Our Ref: GB10604

PLANS AND DOCUMENTS
 referred to in the ULDA
APPROVAL dated 10 / 11 / 09

RE: HAMILTON HARBOUR DEVELOPMENT APPLICATION ADDENDUM

1 SITE PLAN

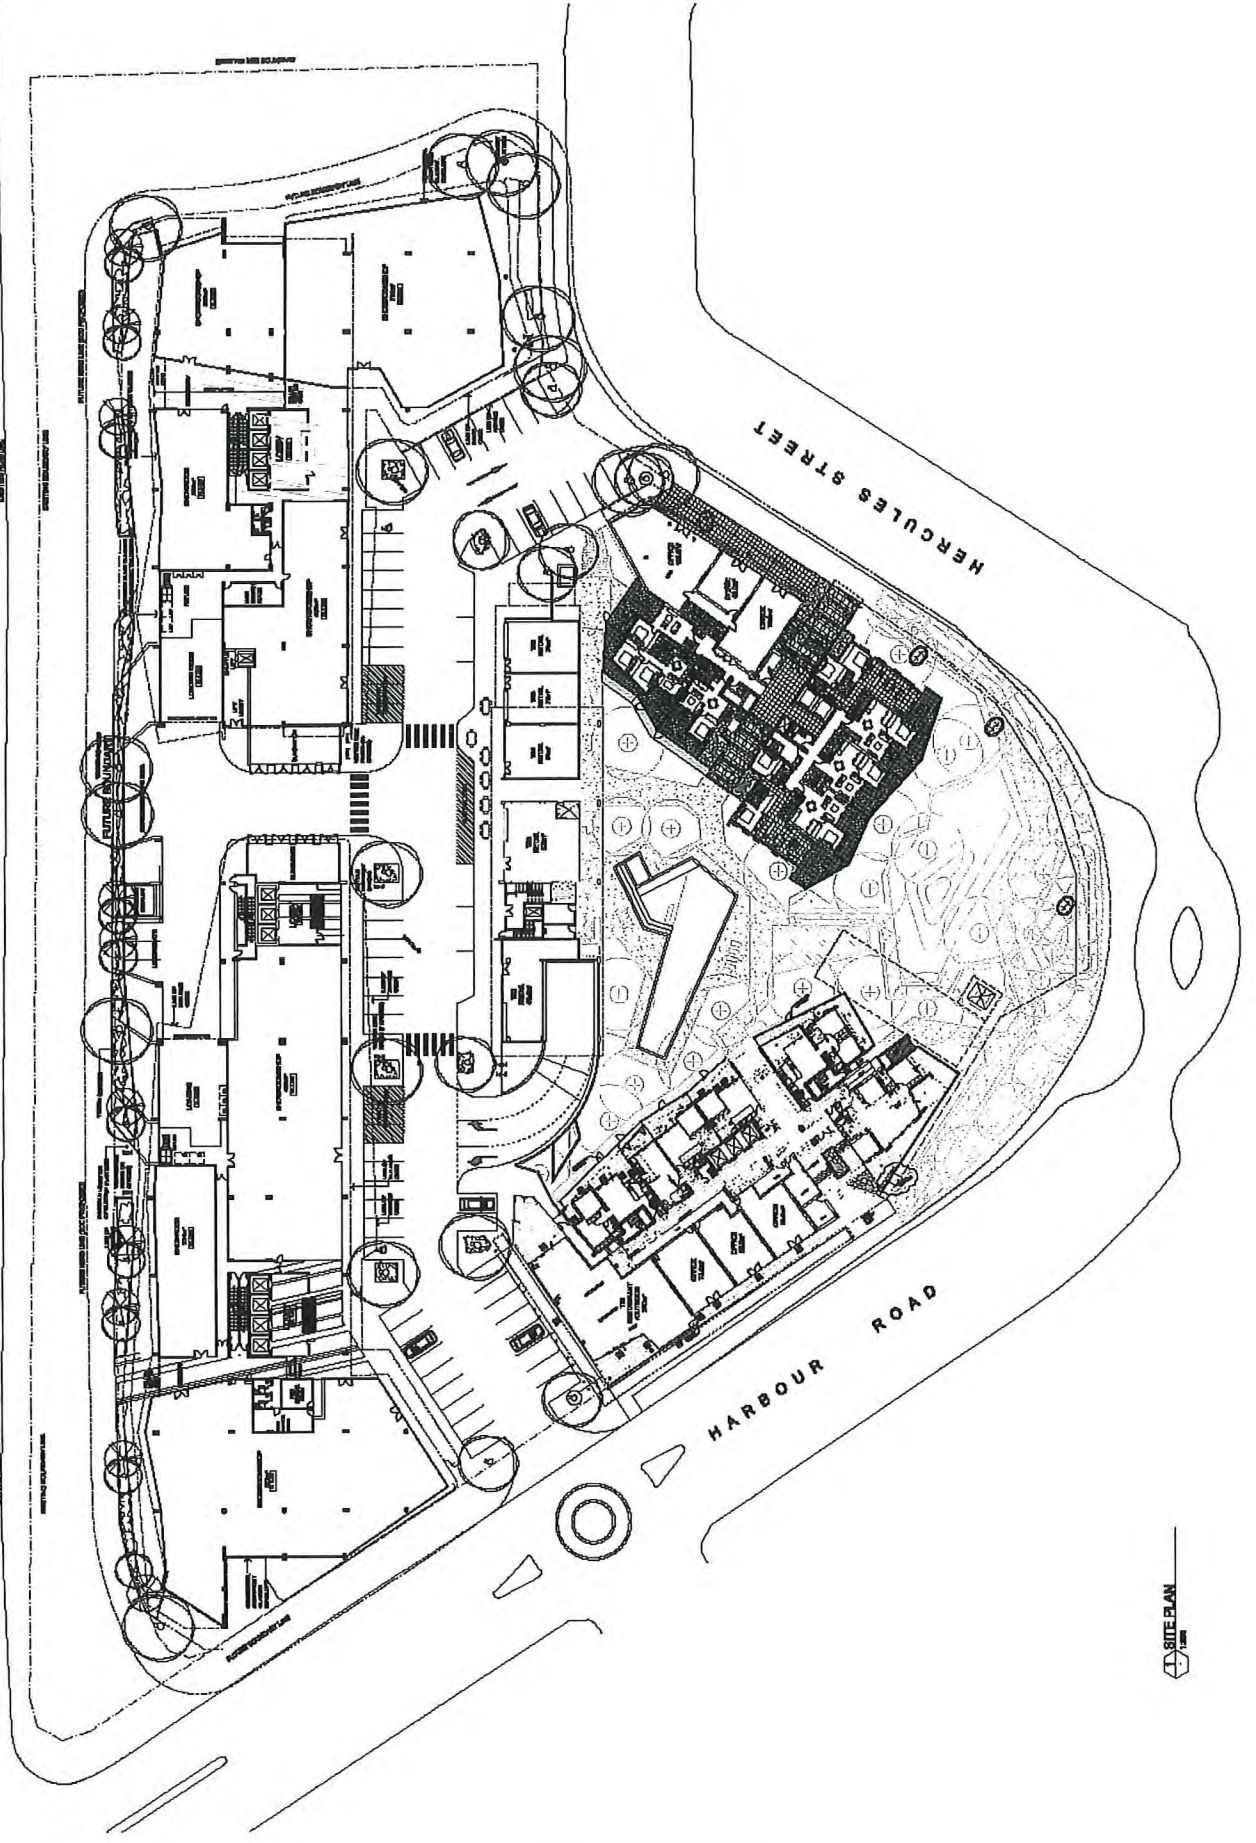
The car parking dimensions at the ground level, for 90 degree parking bays, are a minimum of 2.6m wide by 5.4m long with an aisle width of 7.5m. This meets the requirement of AS/NZS 2890.1-2004 for high turnover parking.

A number of parallel parking bays are located in the at-grade and basement level car parks. These bays are 2.4m wide by 6.0m long in the 'at-grade' car park and 2.1m wide by 6.6m long on basement levels. Given the access aisles are 7.5m (two-way) in the 'at-grade' car park and 6.2m in basement levels, these spaces meet AS/NZS 2890.1-2004 with regard to width and length.

1 FLOOR PLAN - BASEMENT LEVEL 2

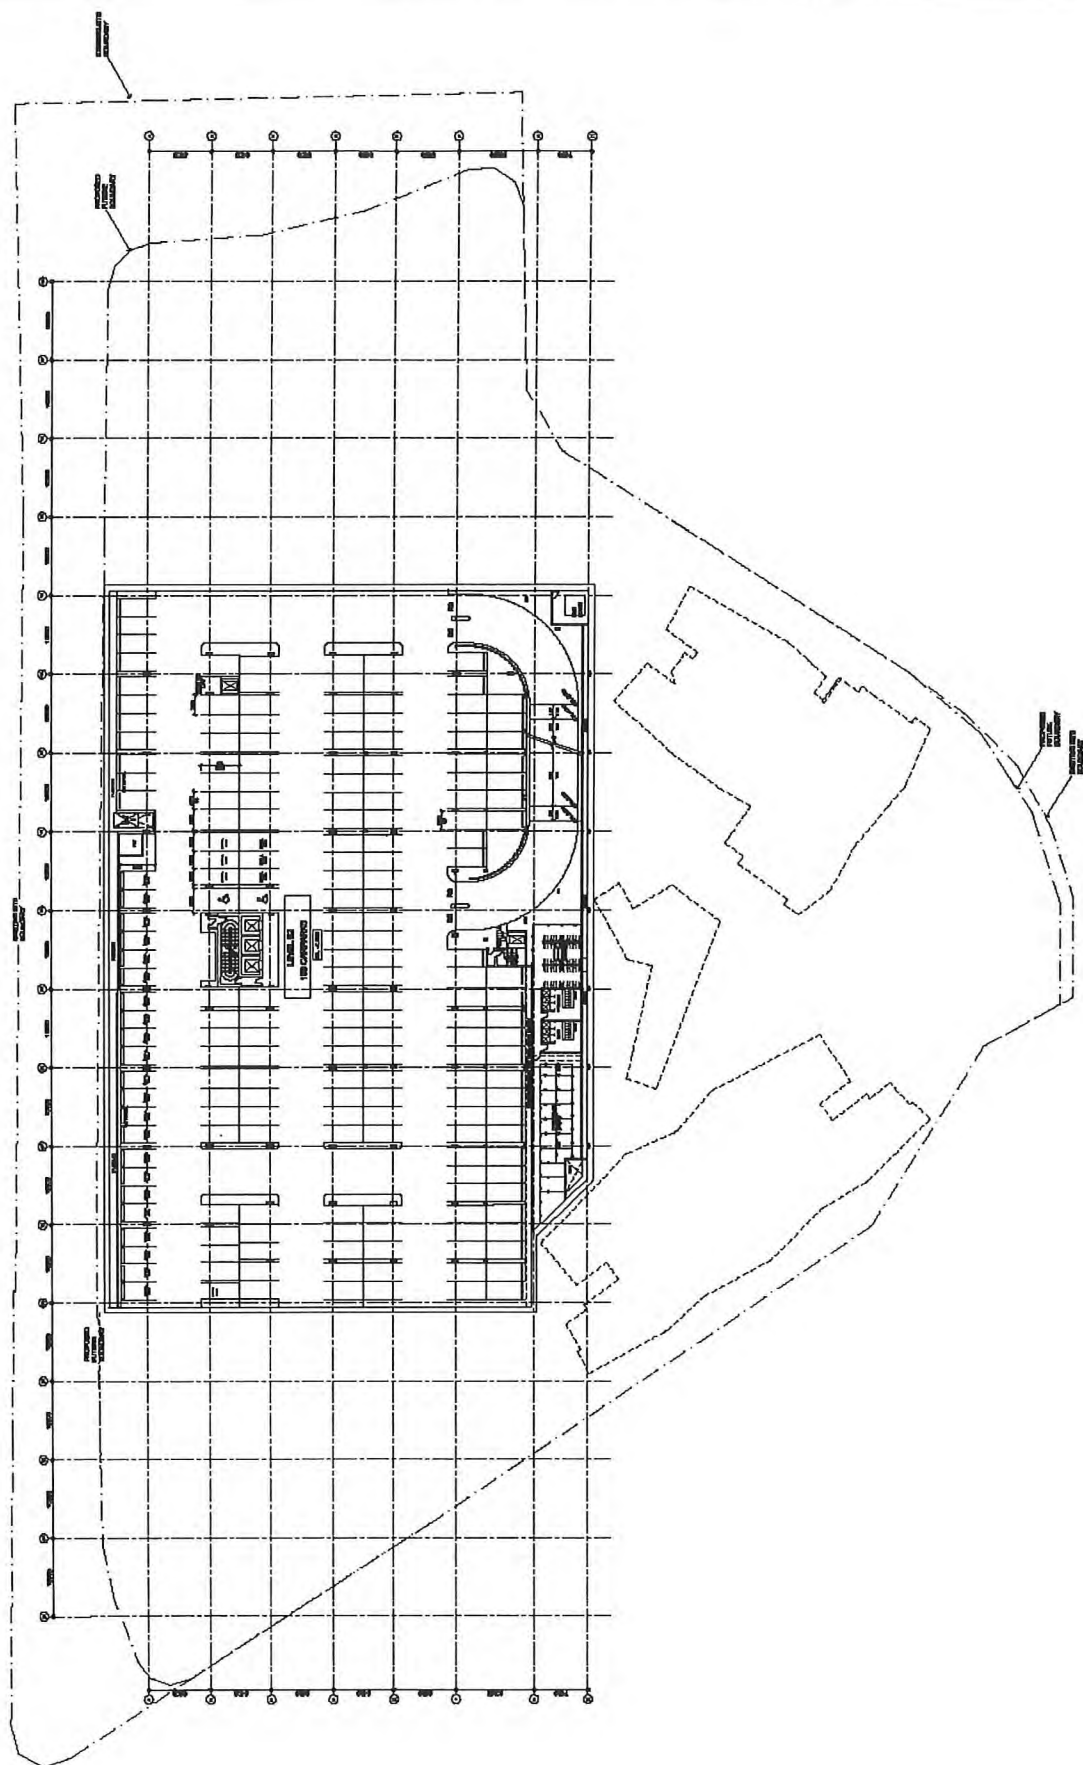
Four disabled car parking bays have been provided at the Ground and Basement Level Two plan, these bays are required to have a maximum gradient of 1:40. The provision equates to 2% - 3% of the total supply at the Ground Level and 1% of the supply within Basement Level Two.

It is recommended that a further six spaces be allocated on the basement levels for disabled car parking, this would equate to 1% of the total basement parking supply.

AUTOTURN SIMULATION

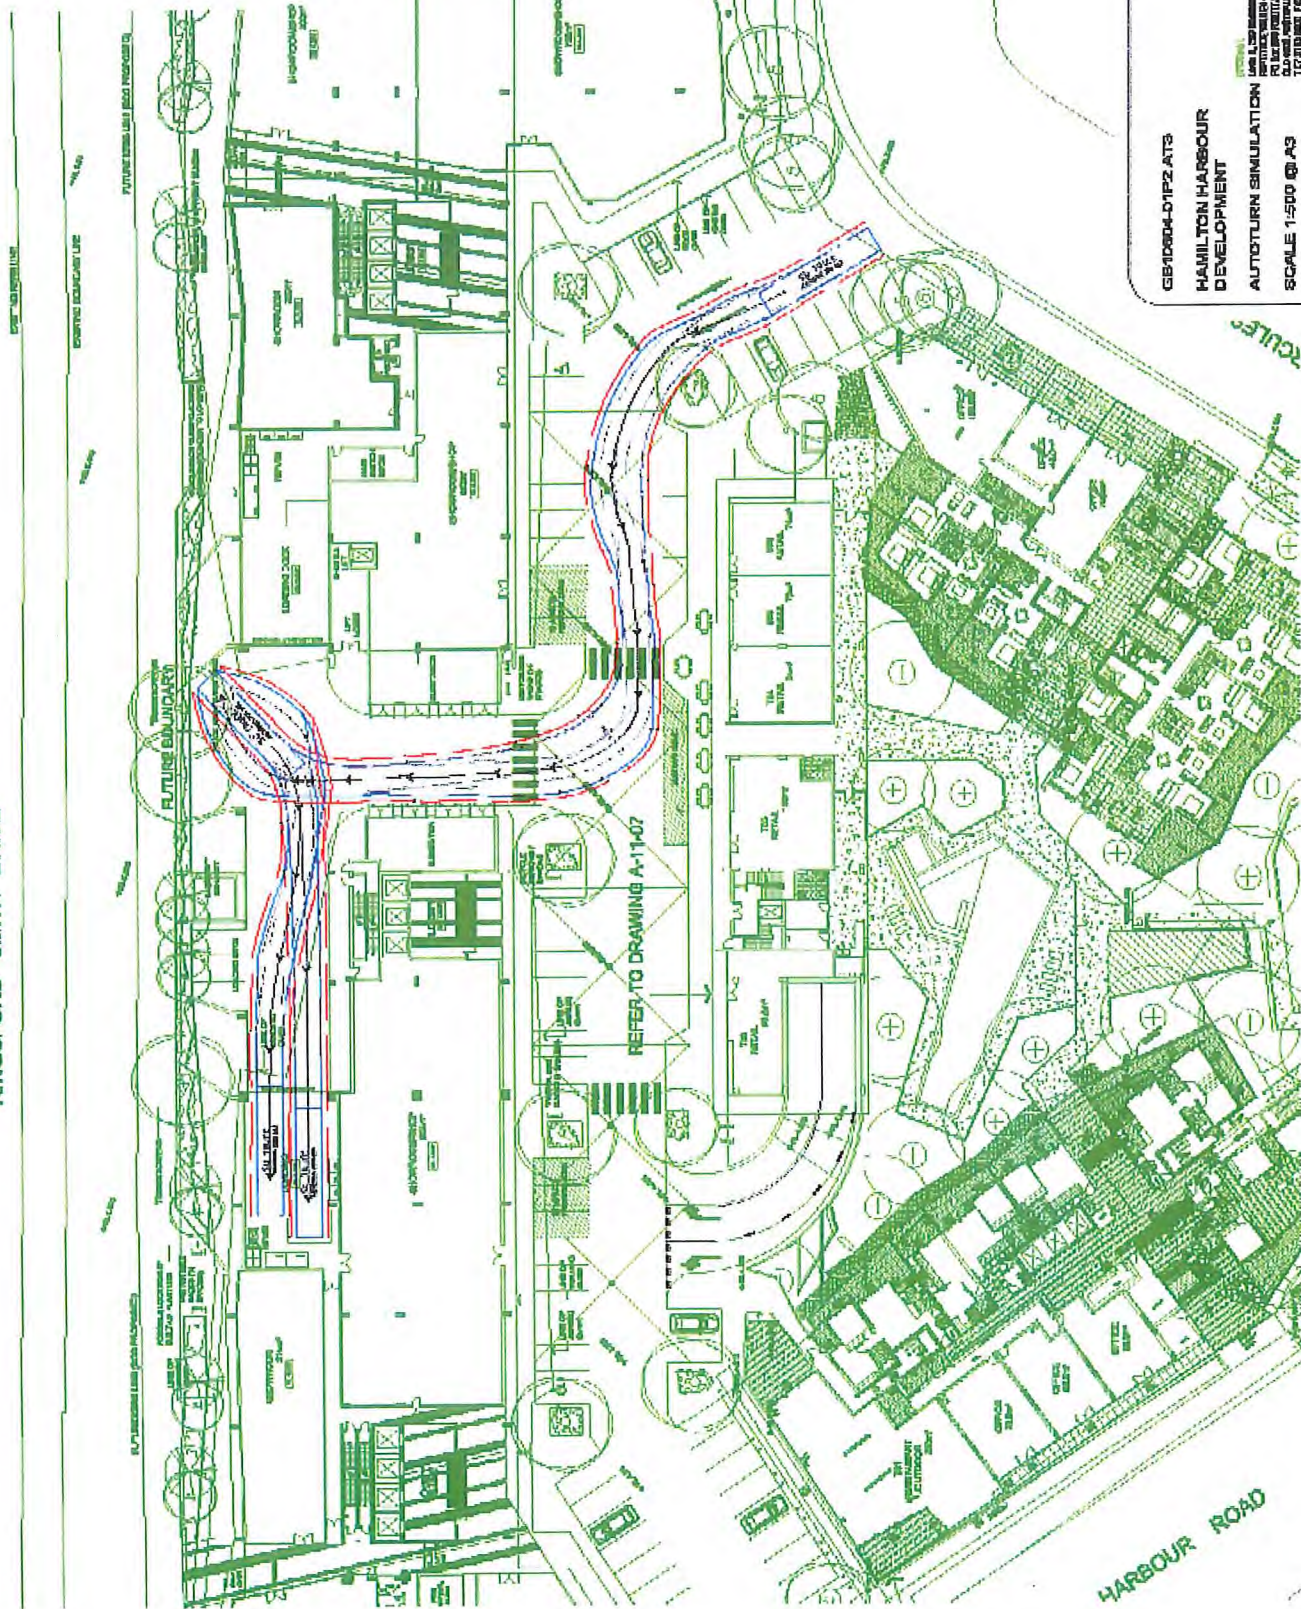
To confirm the accessibility of the central loading area by the various service vehicles, an assessment has been undertaken in AutoTURN. This assessment indicates that the dock is accessible by four large rigid vehicles, independently of each other, whilst entering and exiting the site in a forward direction.
